Space House

Planning Condition Discharge Report

Conditions 3LBC c)

For Seaforth Land

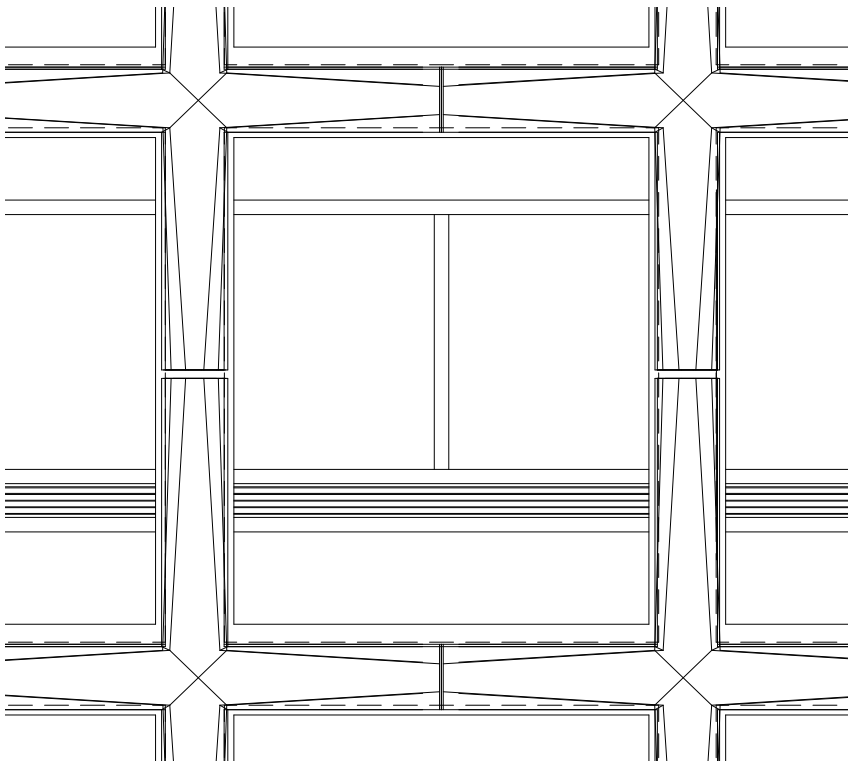
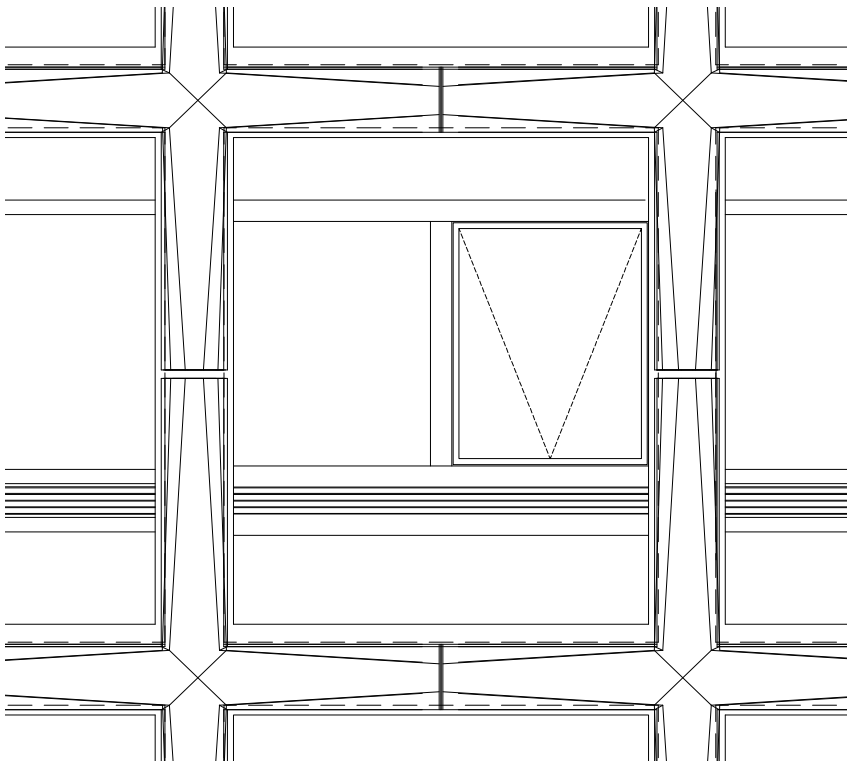
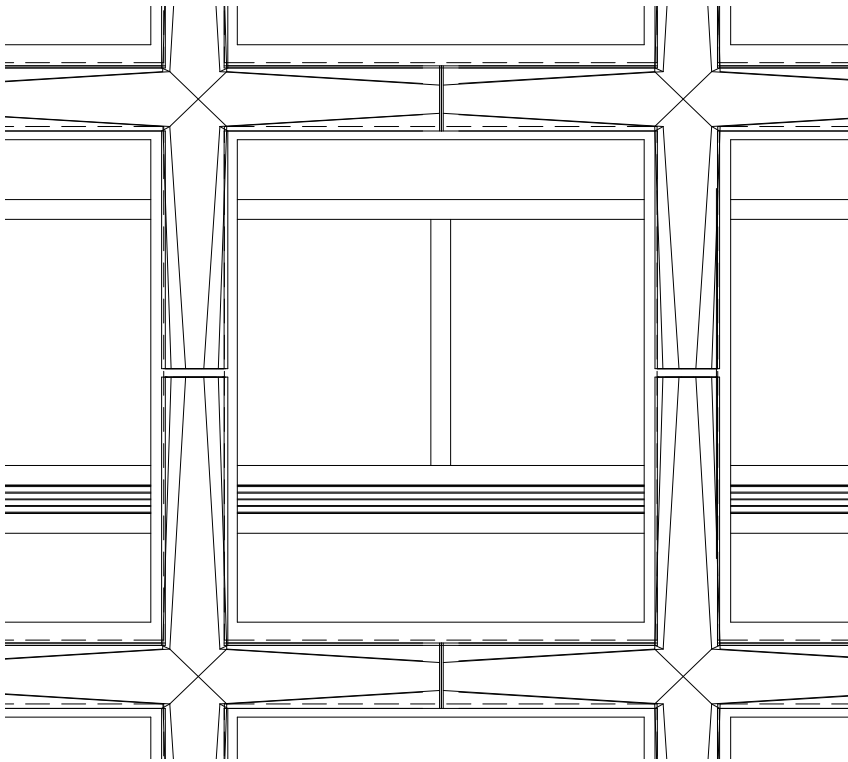
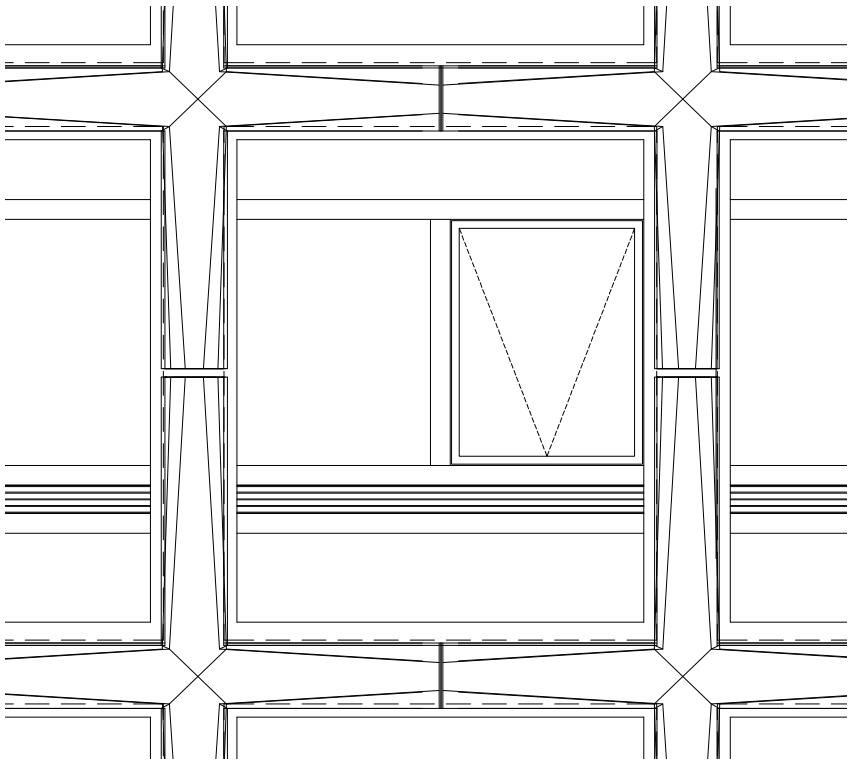
Fig. 2.1.1 and 2.1.2 represent the S73 consented design for the fixed and openable window units. The perimeter frame size was the same for both units - only the transoms and central mullion were shown wider in the openable window units due to the weight of the openable panel.

A revised openable window design with a wider perimeter frame was presented to Camden planning and design officers during the first PAA meeting dated 12.01.2022. The change was driven by facade subcontractor further design development.

Camden raised concerns regarding the difference in frame width between the fixed window units and openable window units and how unbalanced the building elevation now looked.

With these comments in mind we have reviewed the design with the facade specialist to try and reduce the overall perimeter frame of the openable windows to match the fixed units but due to the load of the openable panels a frame reduction was not a viable option.

In order to achieve a balanced elevation the other option would be for the fixed units to match the openable windows perimeter frame and transoms sizes as shown in Fig. 2.1.3 and 2.1.4. Revised design has been shown to planning officers during a site visit on 28.01.2022 and officers were supportive of the revised design in principle.

DRAWING No
14616-CLL-T1-ZZ-DR-X-10103

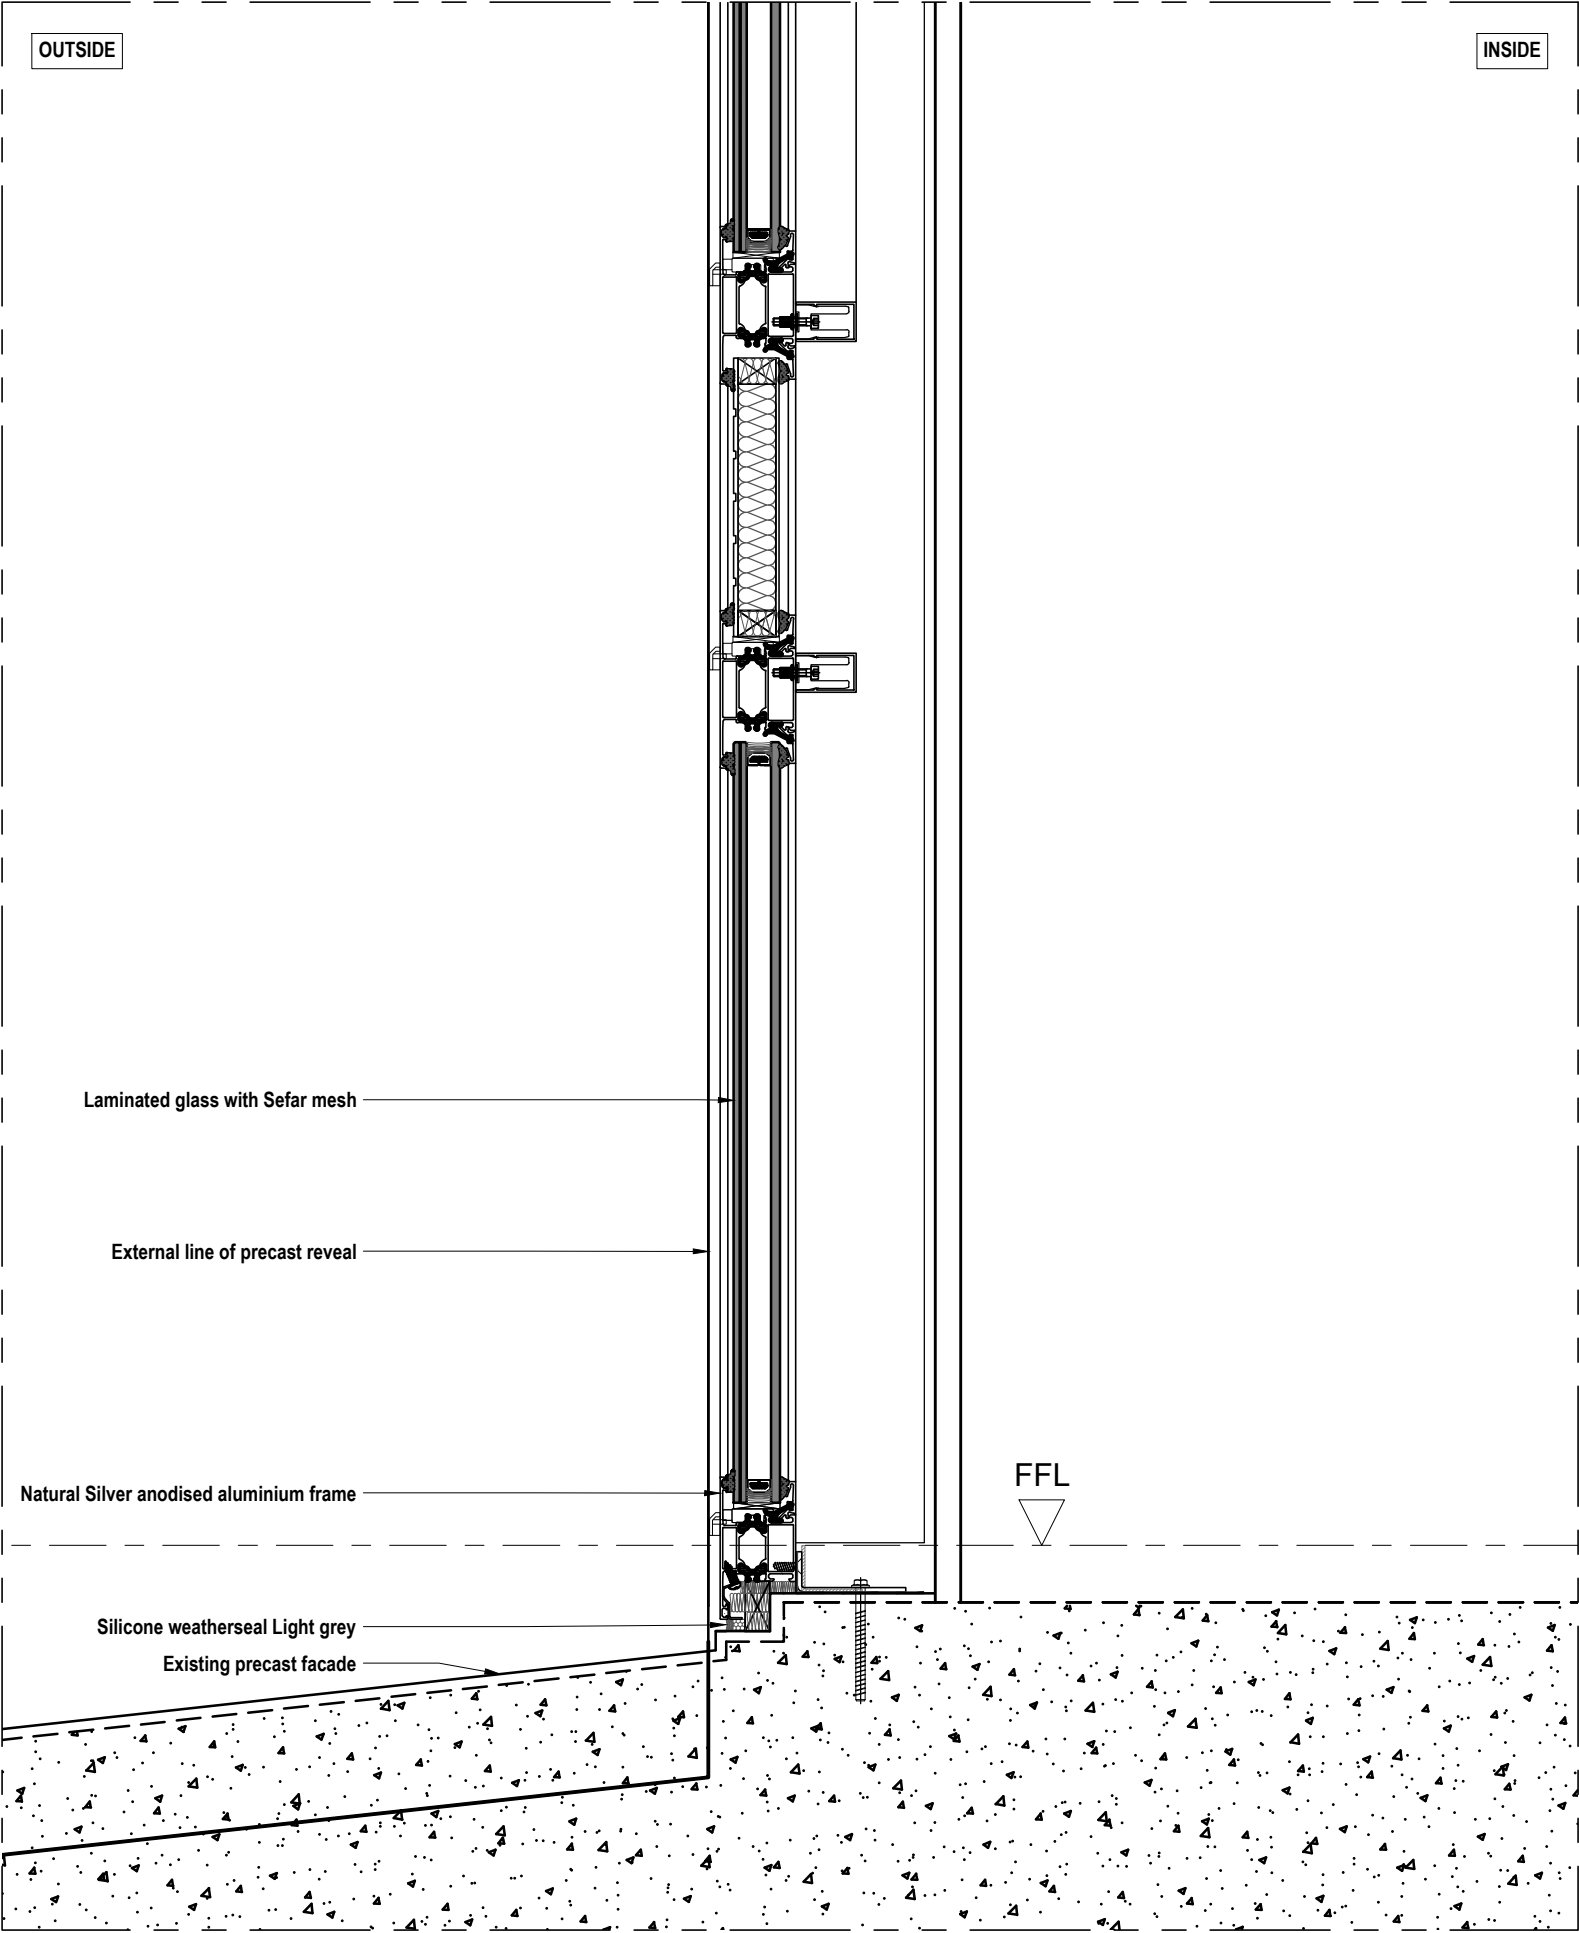
14616-CLL-T1-ZZ-DR-X-10101 and 14616-CLL-T1-ZZ-DR-X-10103 previously consented under 3LBC c) condition have been updated and uprevved to capture the changes described above.

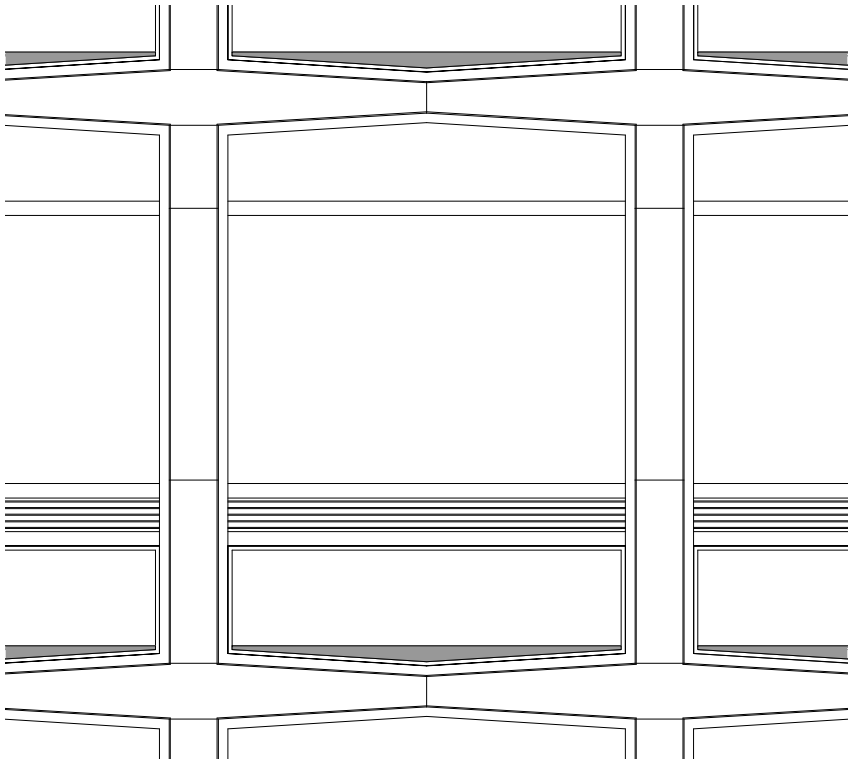
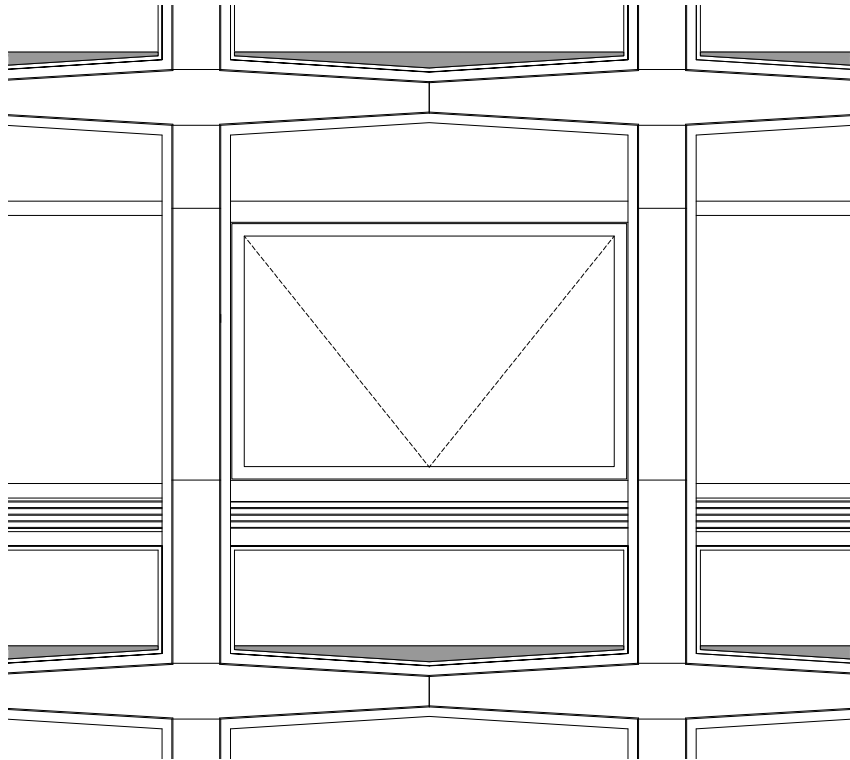
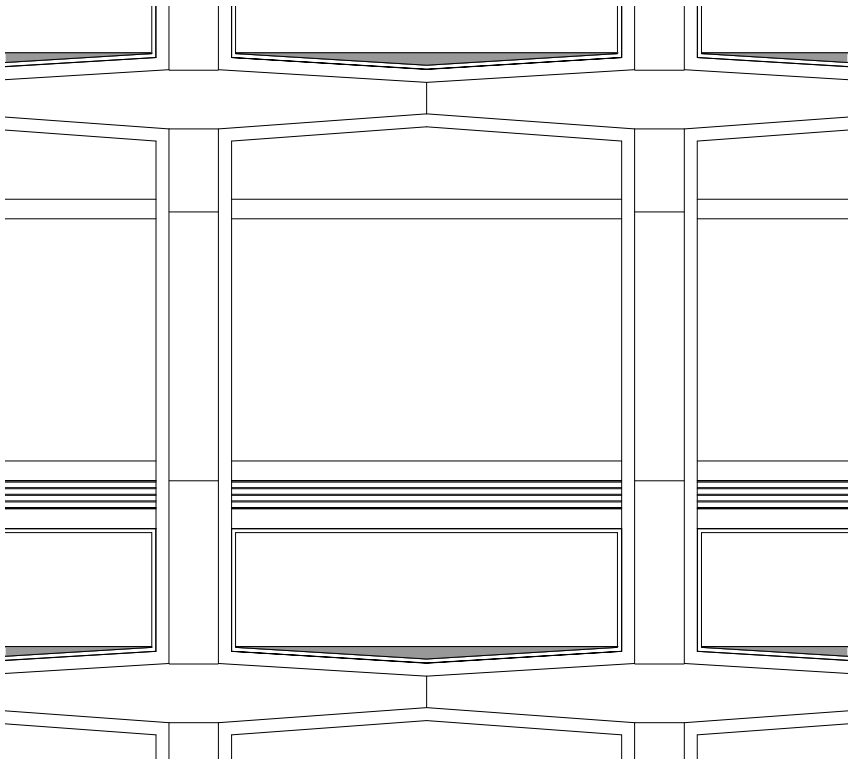
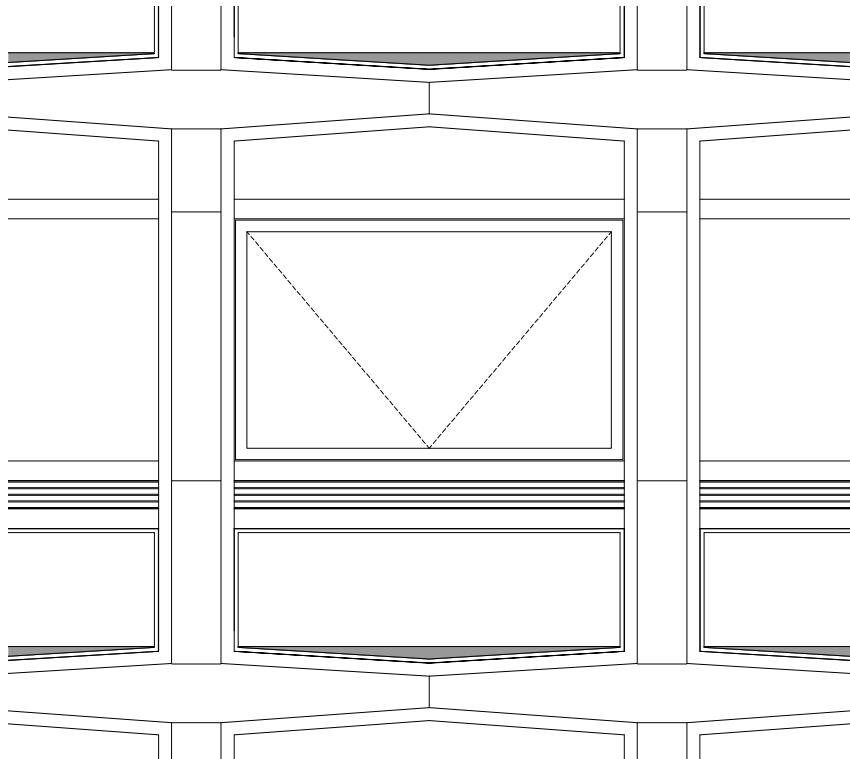
Fig. 2.2.1 and 2.2.2 represent the S73 consented design for the fixed and openable window units. The perimeter frame size was the same for both units - only the transoms were shown wider in the openable window units due to the weight of the openable panel.

Kingsway flat elevations made the difference between frame sizes even more obvious when compared to the Tower elevation (circular building with recessed windows).

Kingsway window units took on the same approach as the Tower design and the proposed units can be seen in Fig. 2.2.3 and 2.2.4.
